ADDENDUM #3

RFP for: Pecan Hill Tree Removal and Sanitary Sewer Retrofit

TREE REMOVAL AND SANITARY **SEWER RETROFIT**

PECAN HILL APARTMENTS 1600 W. LAWNDALE SAN ANTONIO, TEXAS

SK-1 SHEET C1.1

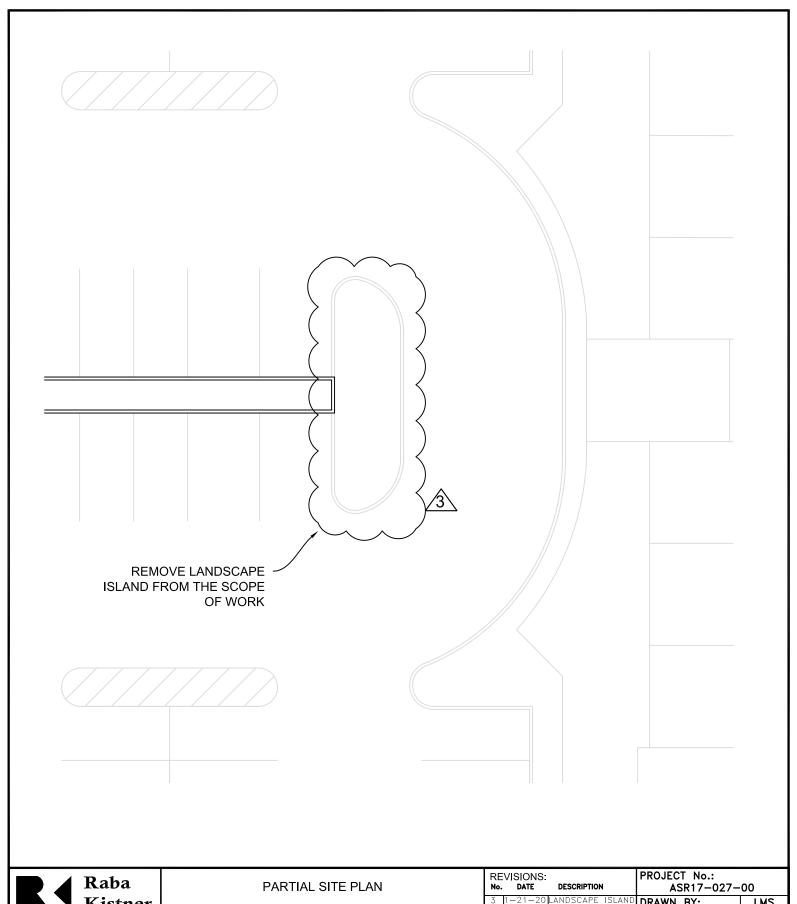
Attached is the Detail for the landscape island in the front of Pecan Hill. Since there are no trees planned for this part of the island, leave it in place.
